Attachment G
Exceptions to Design Standards

Fact Sheet Exceptions to Mandatory Design Standards

LAUREN PROCTOR, Registered Civil Engineer
CH2M HILL

ATTACHMENT 7

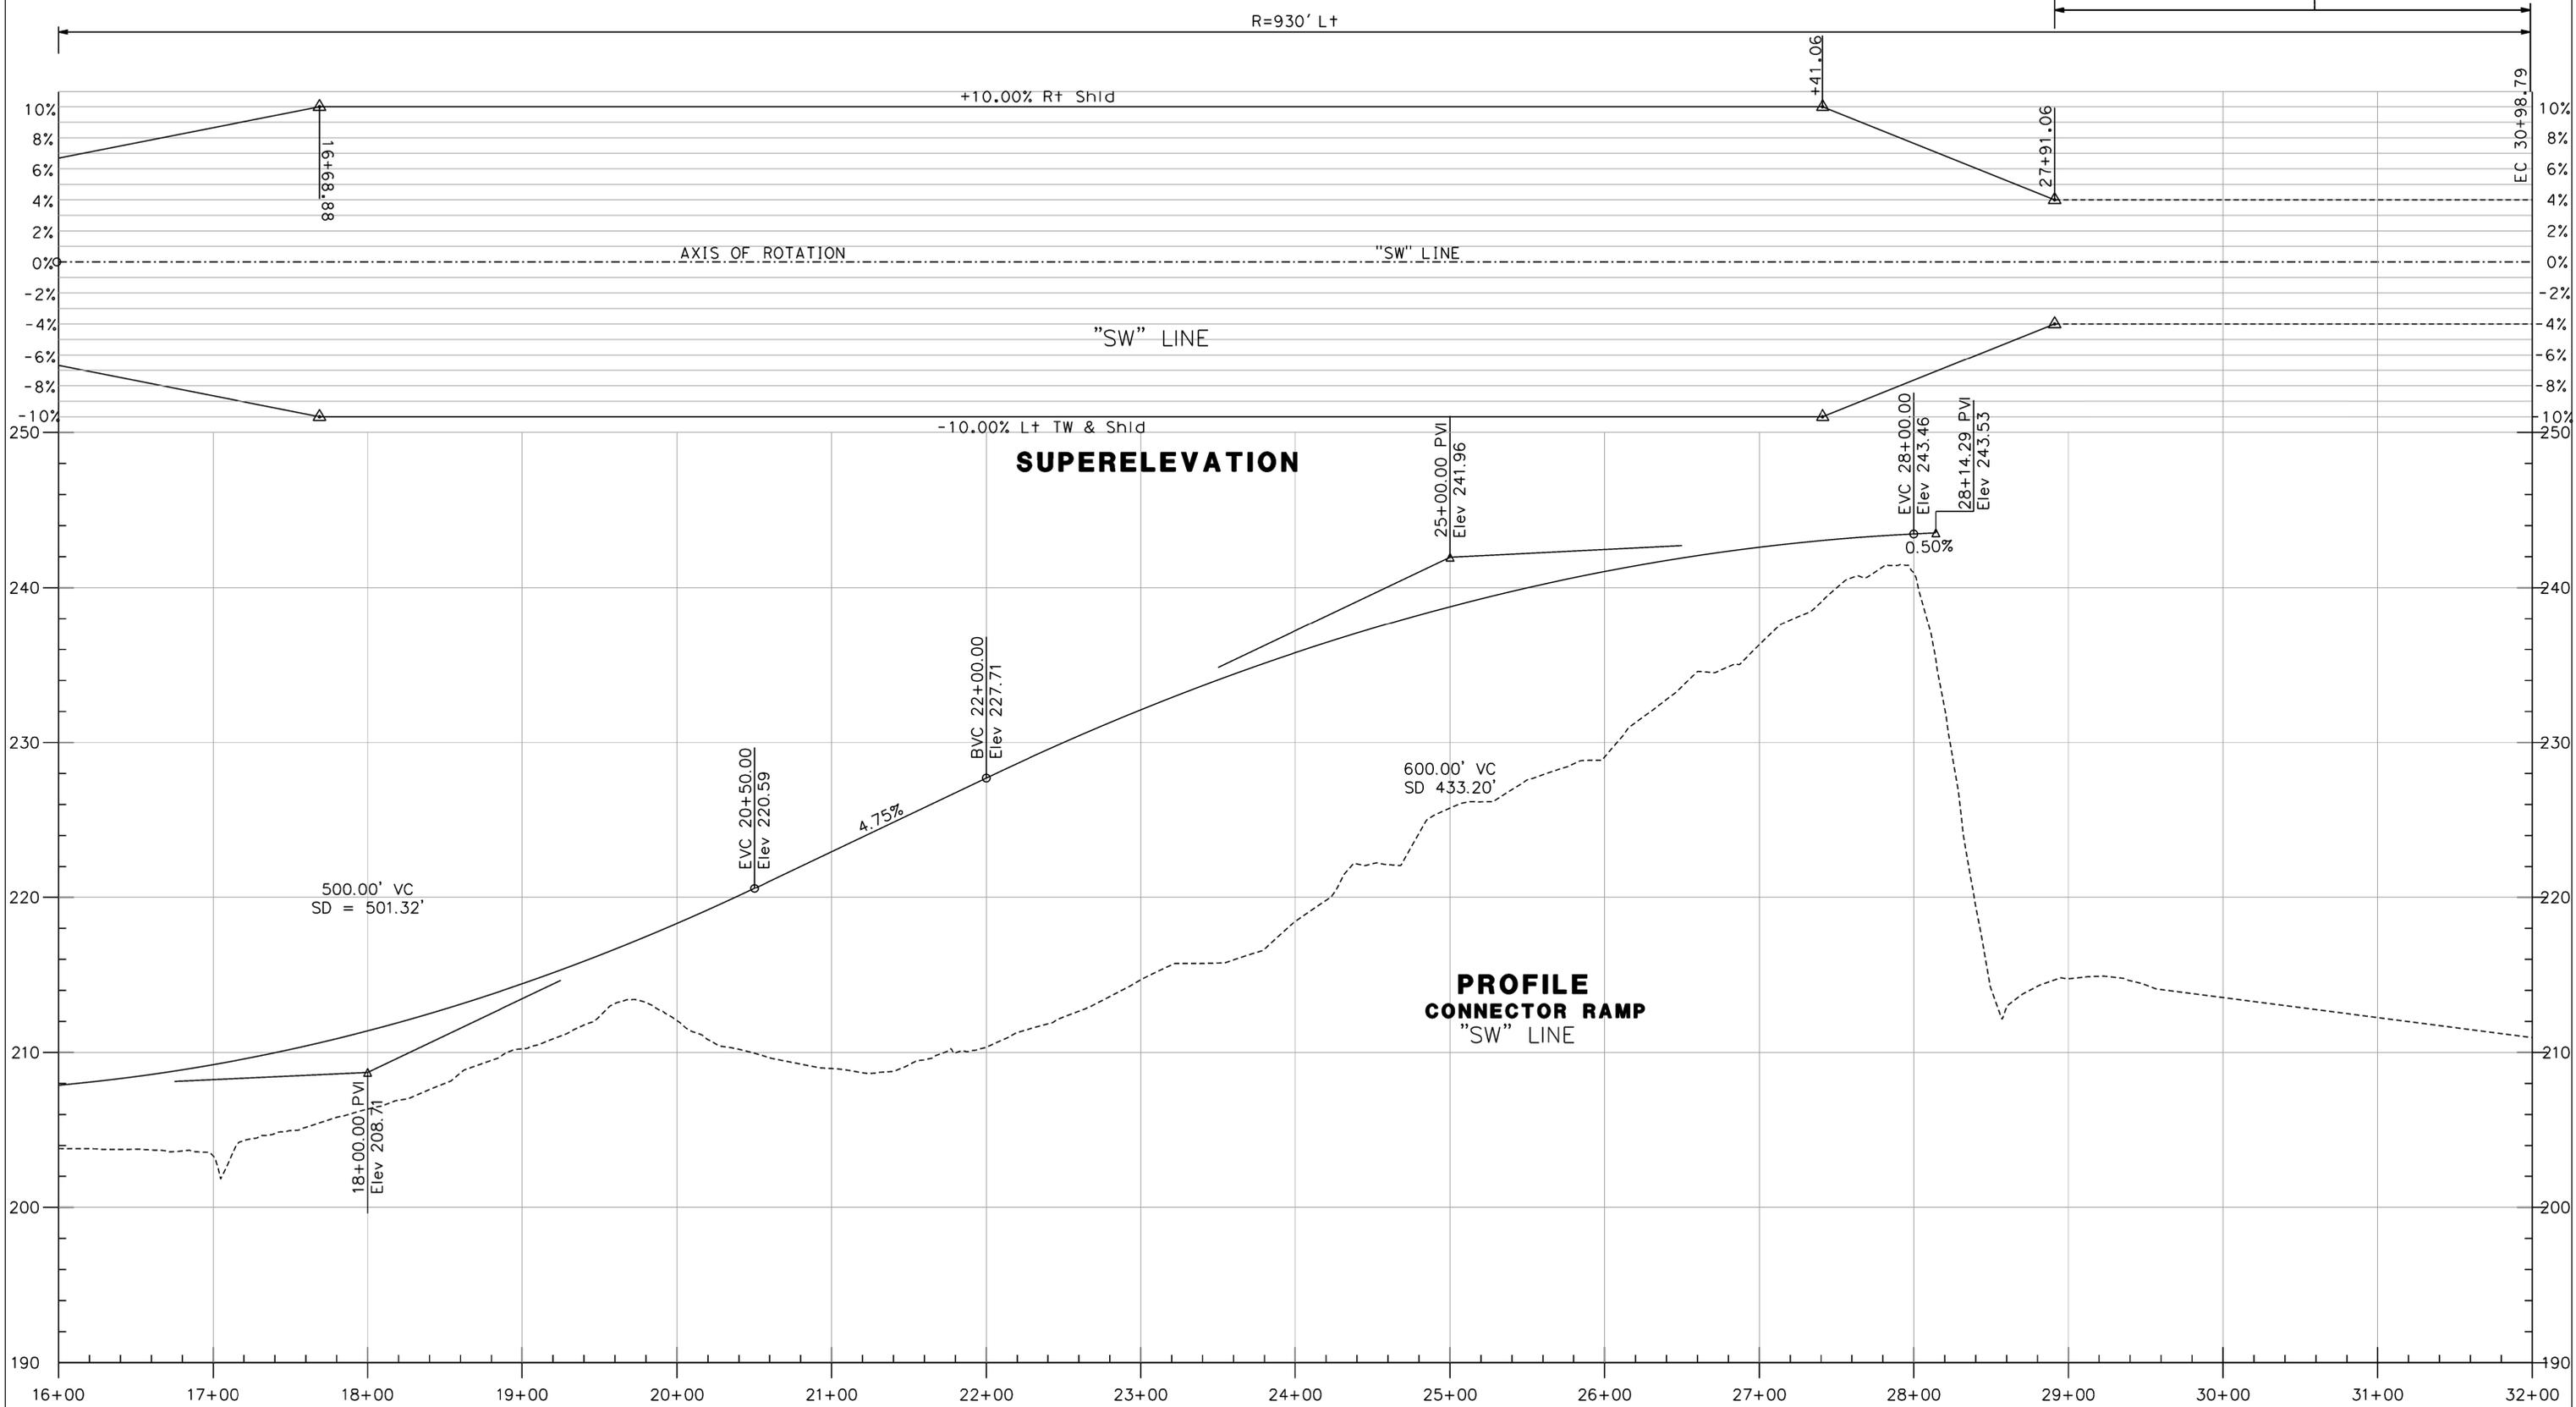
Location F: SR 65 SB to I-80 WB Connector, “SW” station 27+91.06 to 30+98.79, the proposed 930' curve will have superelevation rate of 4%. (See Attachment 7)

The standard superelevation required for 930' curve is 10%.

**MANDATORY EXCEPTION NO. 1F
SUPERELEVATION = 4%
LESS THAN 10% STANDARD SUPERELEVATION**

Location F: The reason for the design exception for location B is to match the 4% slope of East Roseville Viaduct. The Viaduct has a minimum clearance required over UPRR.

The proposed design with a non-standard feature will still meet the 45 mph design speed based on comfortable speed. The maximum comfortable speed based on the proposed design with 4% superelevation rate is 51 mph.

Conformance to standard would require changing the profile of SR 65 to increase the finish elevation by approximately 6 feet at Viaduct. A 2100' length of existing viaduct will need to be replaced along with reconstruction 300' of roadway to conform.

ATTACHMENT 8

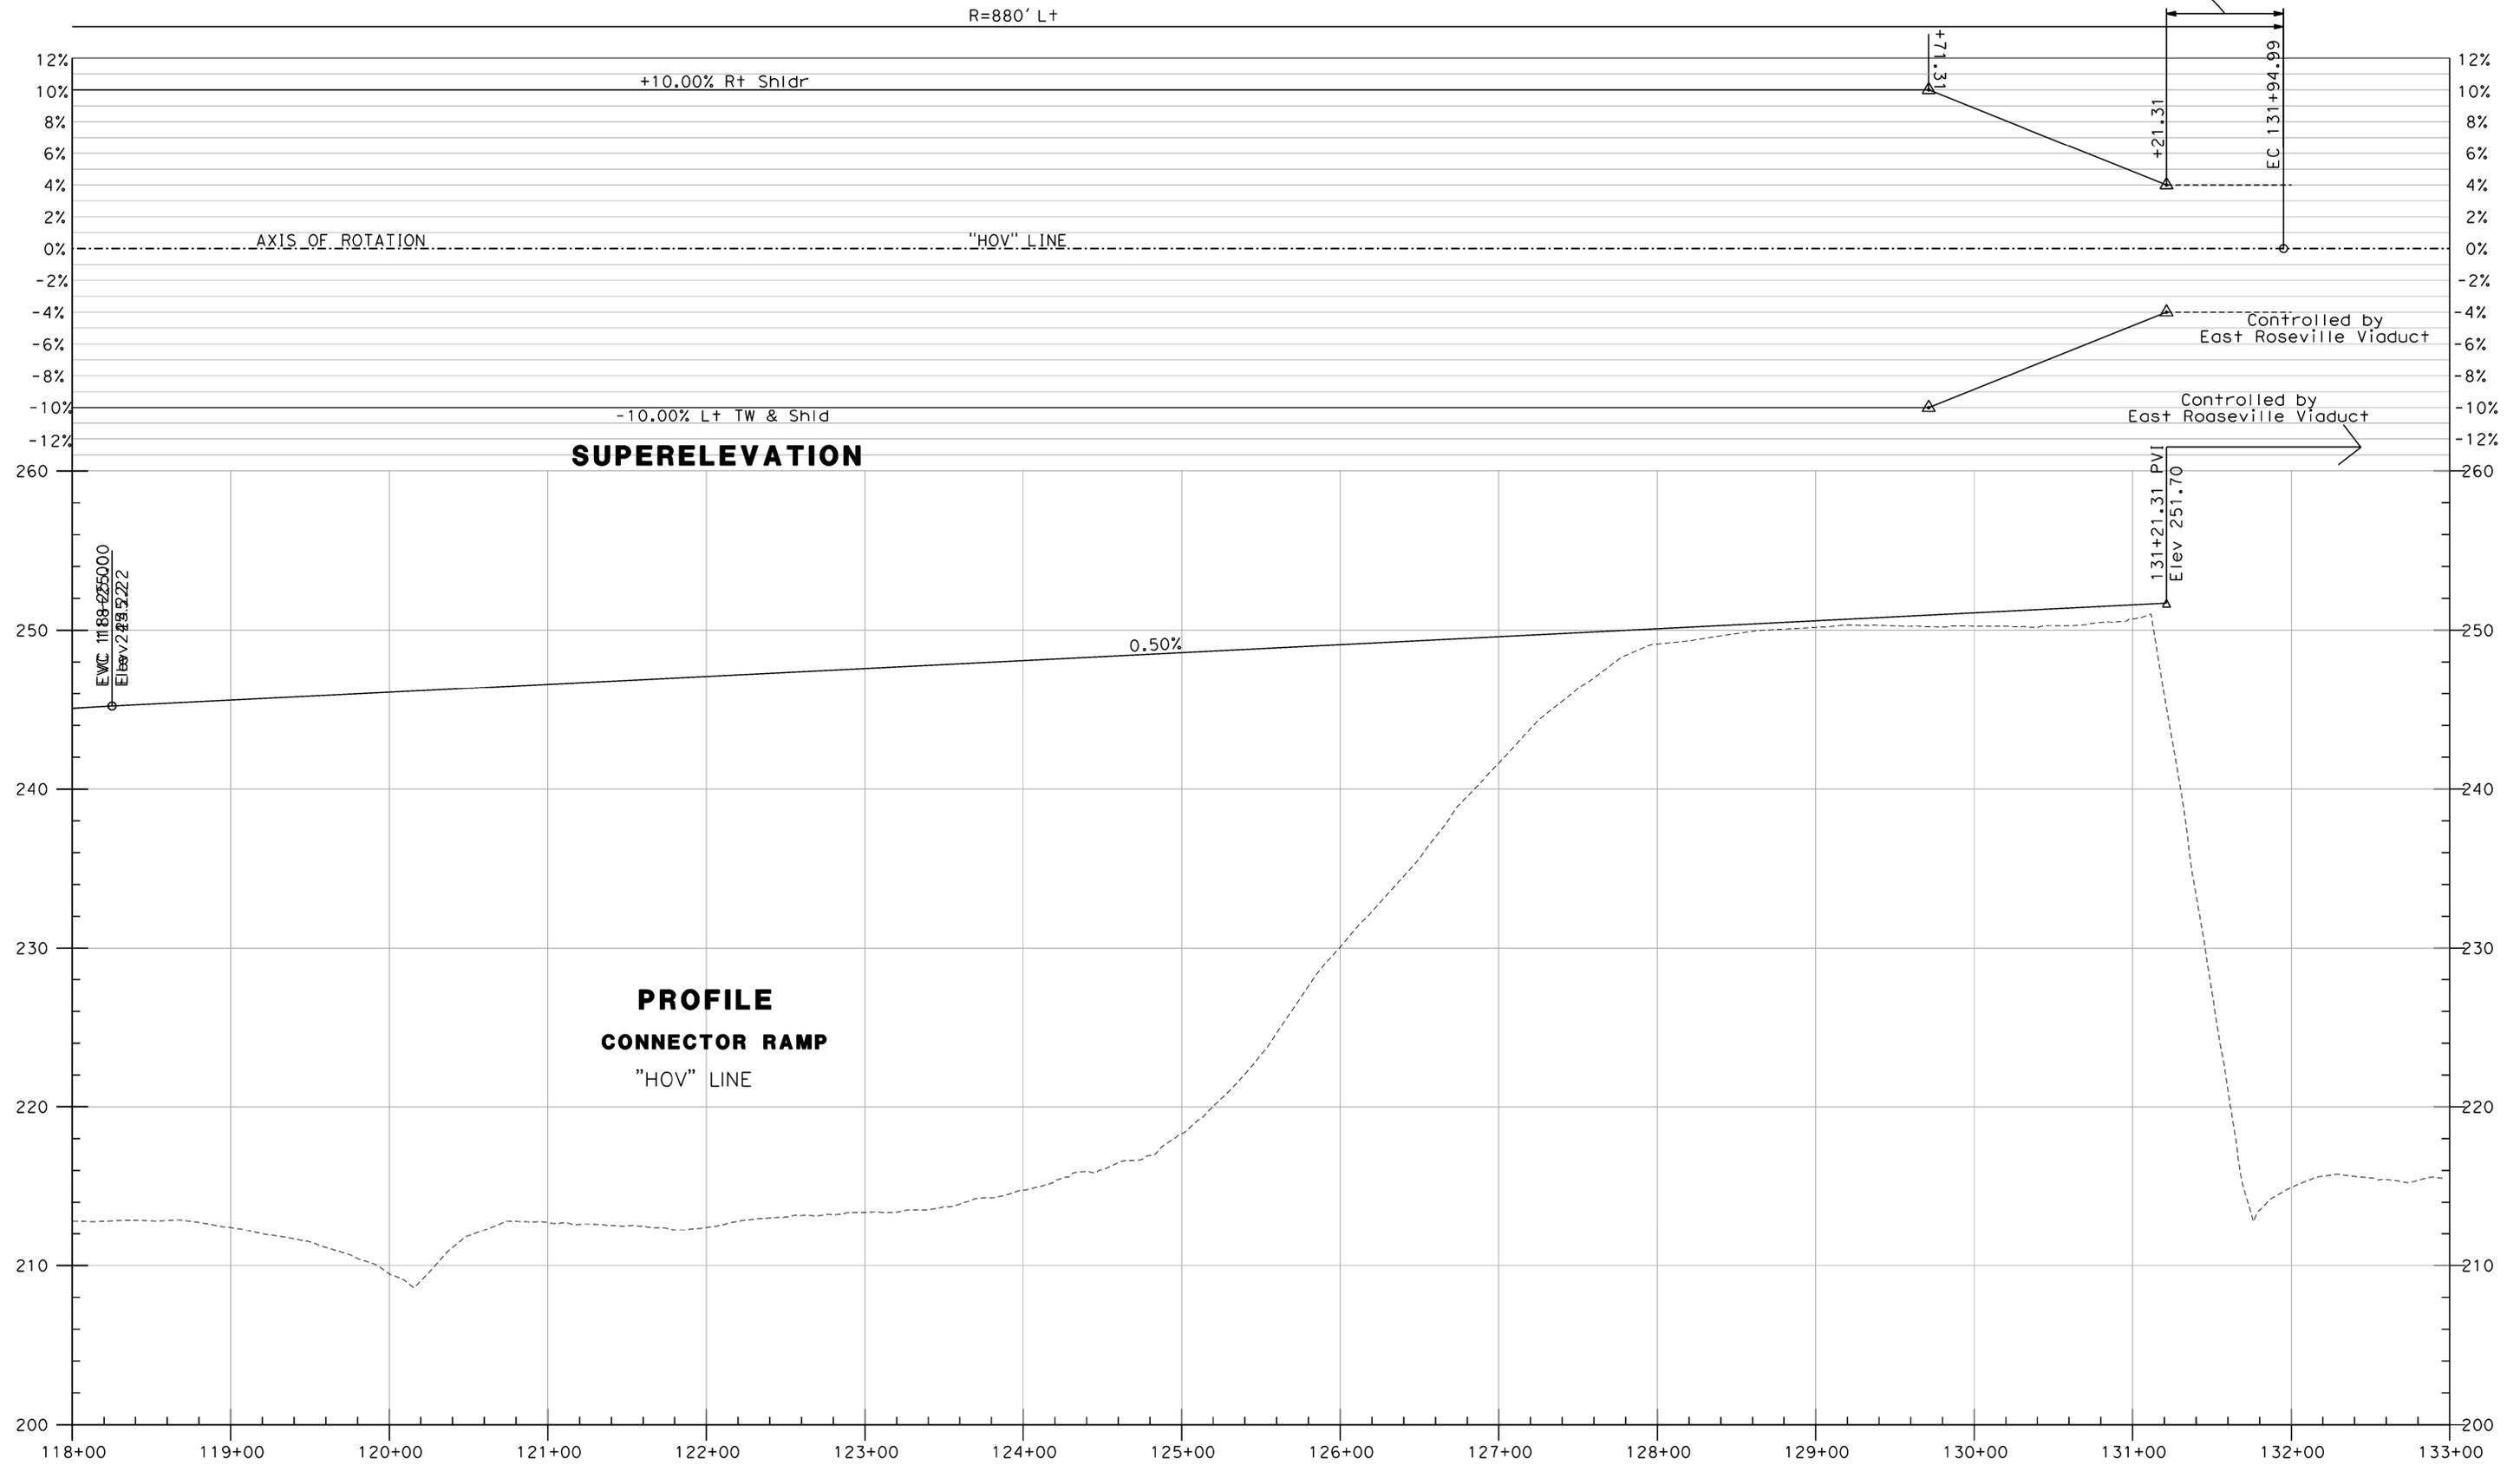
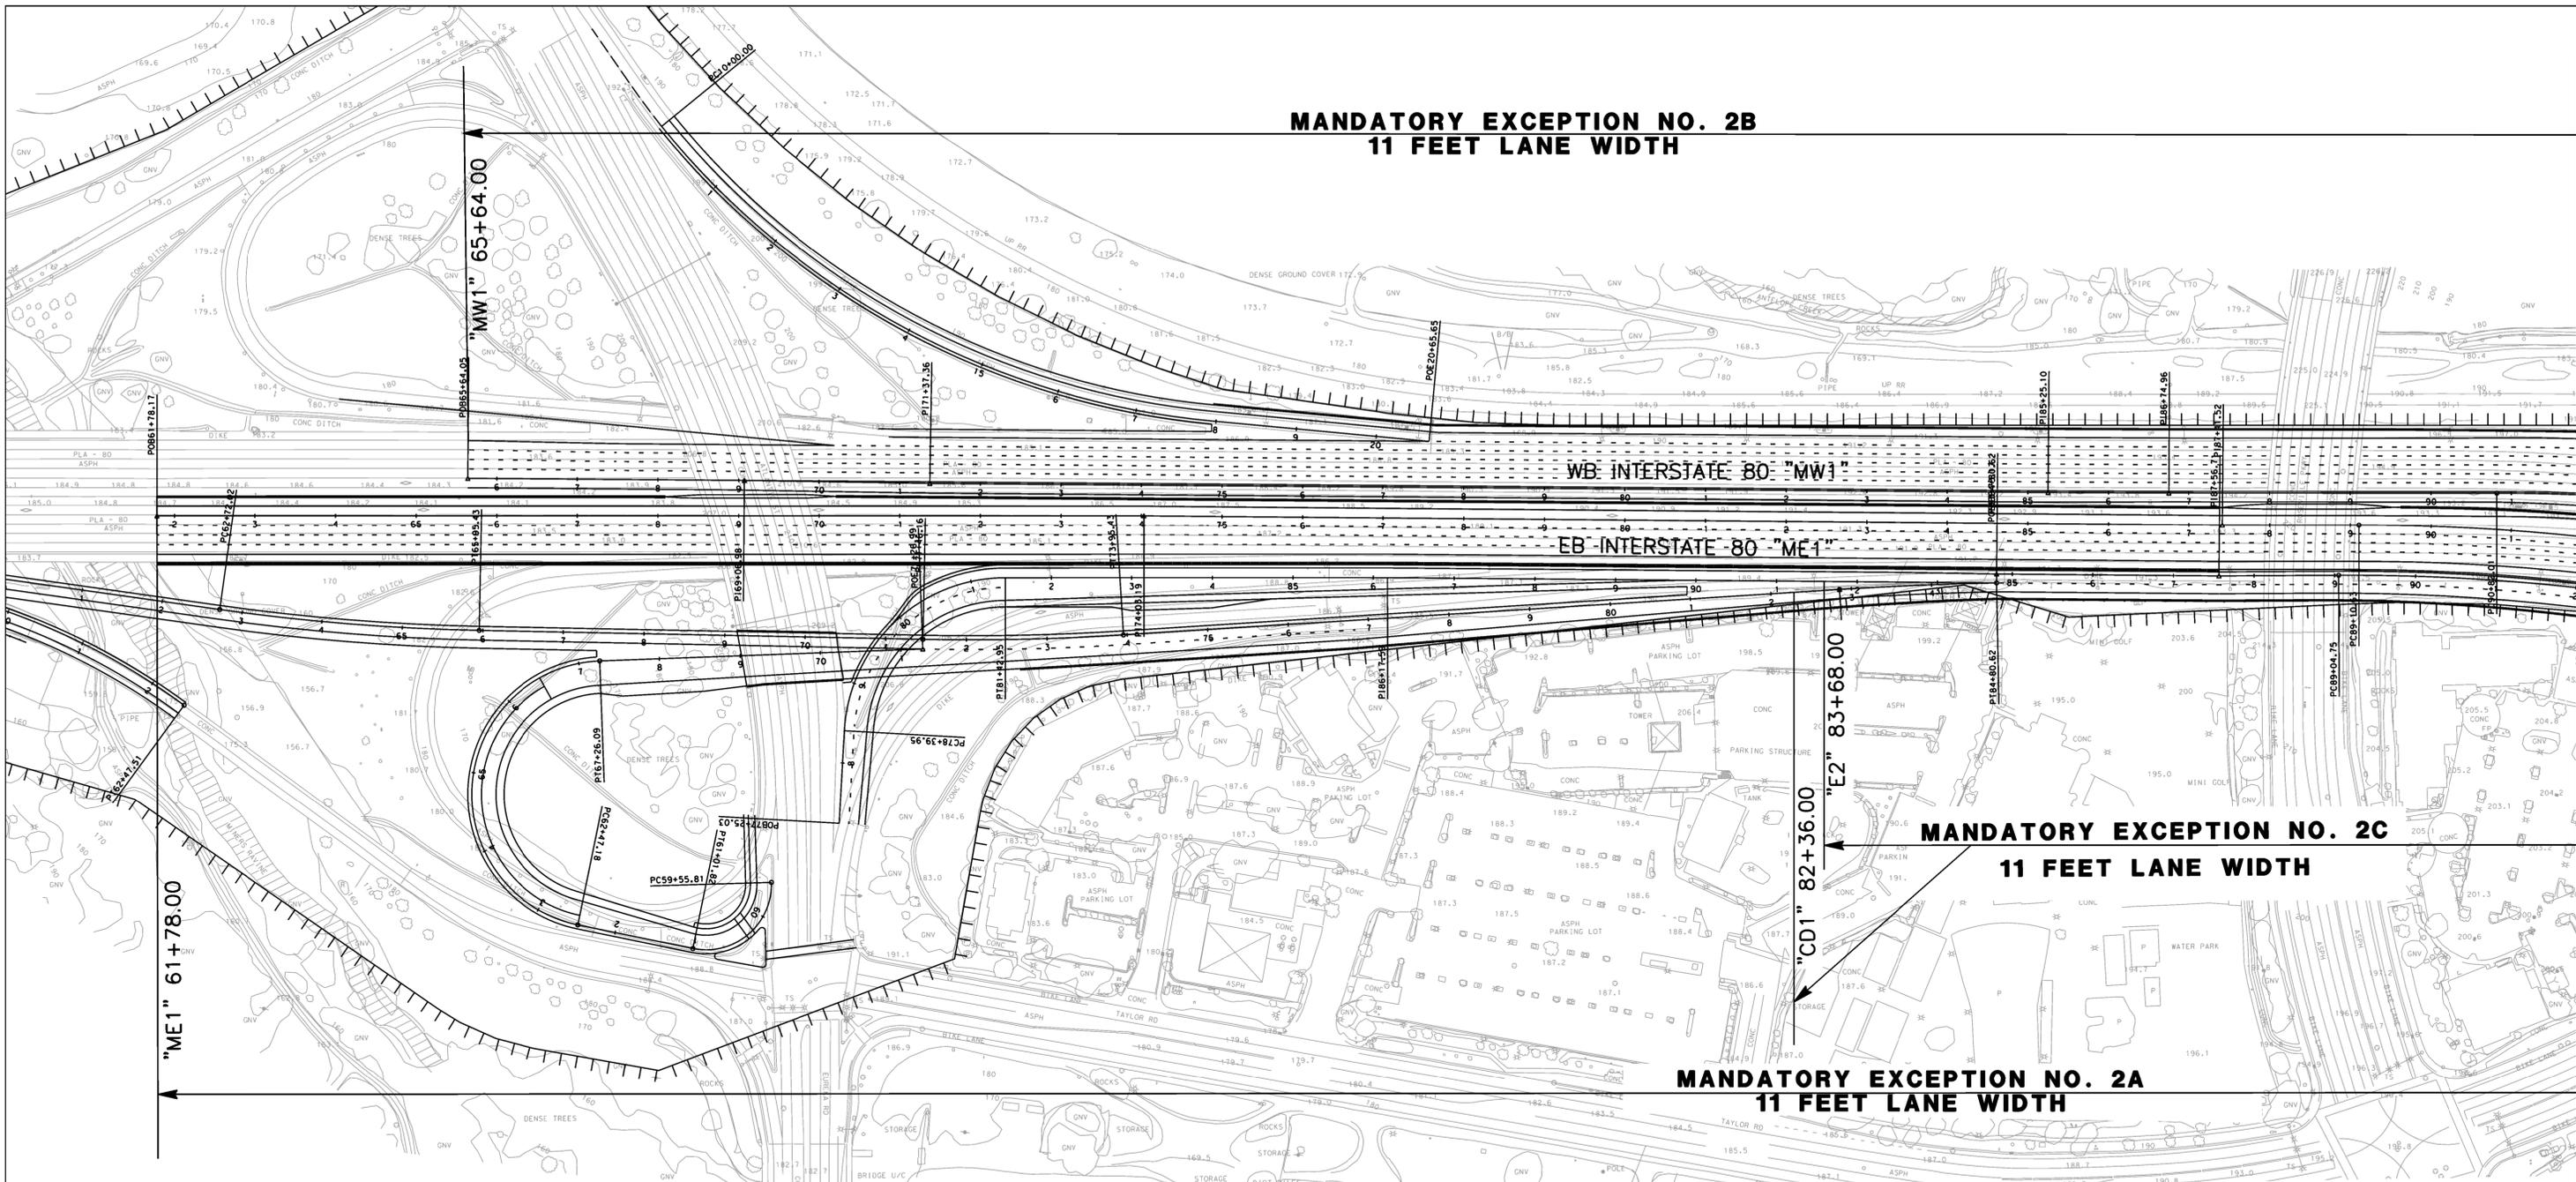
Location G: HOV Direct Connector, “HOV” station 131+21.31 to 131+94.99, the proposed 880' curve will have superelevation rate of 4%. (See Attachment 8)

The standard superelevation required for 880' curve is 10%.

MANDATORY EXCEPTION NO. 1G
SUPERELEVATION = 4%
LESS THAN 10% STANDARD SUPERELEVATION

Location G: The reason for the design exception for location B is to match the 4% slope of East Roseville Viaduct. The Viaduct has a minimum clearance required over UPRR.

The proposed design with a non-standard feature will still meet the 45 mph design speed based on comfortable speed. The maximum comfortable speed based on the proposed design with 4% superelevation rate is 49 mph.

Conformance to standard would require changing the profile of SR 65 to increase the finish elevation by approximately 6 feet at Viaduct. A 2100' length of existing viaduct will need to be replaced along with reconstruction 300' of roadway to conform.
